Rockville Campus – Robert Parilla Performing Arts Center Asbestos Survey map June 1991

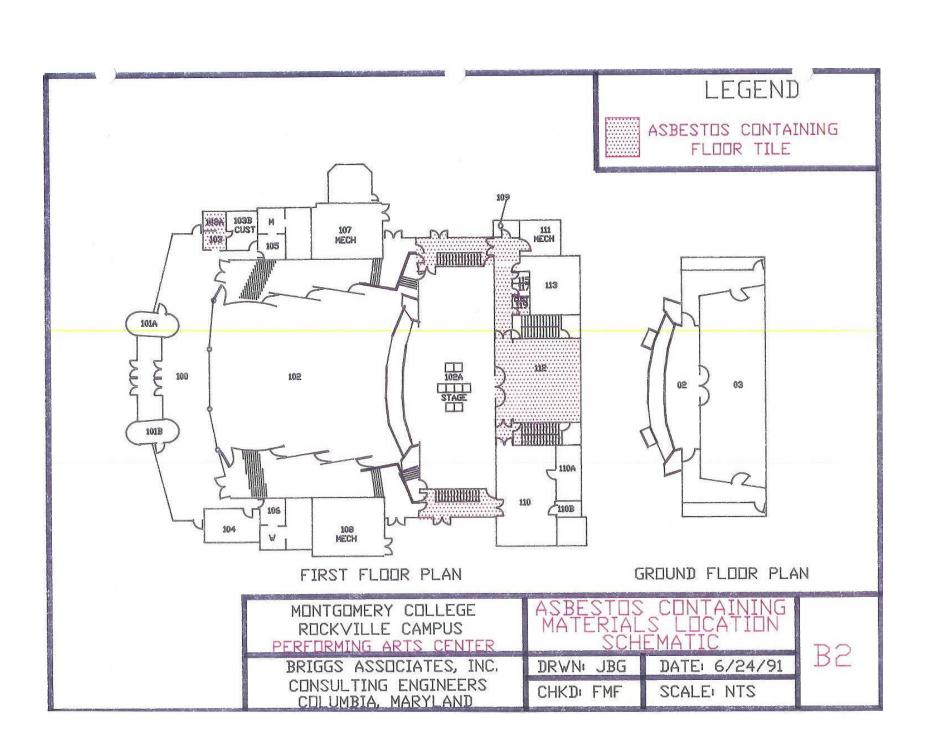
Only some of the floor tile is ACM. Floor tile mastic is <u>not</u> ACM

Errata: Sample 3-RPAC is not positive. LEGEND POSITIVE SAMPLE LOCATION EGATIVE SAMPLE LOCATION HC-RPAC 103B CUST 103A MECH 5-RPAC 107 103 MECH S'ummy O 4D-RPAC 4E-RPAC 3-RRAC 101A OF4A-RPAC RPAC-72998-01 102 1-RPAC 92 03 4B-RPAC 101B 6-RPAC 4G-RPAC 110 110B MECH FIRST FLOOR PLAN GROUND FLOOR PLAN MONTGOMERY COLLEGE SAMPLE LOCATION ROCKVILLE CAMPUS SCHEMATIC PERFORMING ARTS CENTER B1 BRIGGS ASSOCIATES, INC. DRWN: JBG DATE: 6/24/91 CONSULTING ENGINEERS CHKD: FMF SCALE: NTS COLUMBIA, MARYLAND
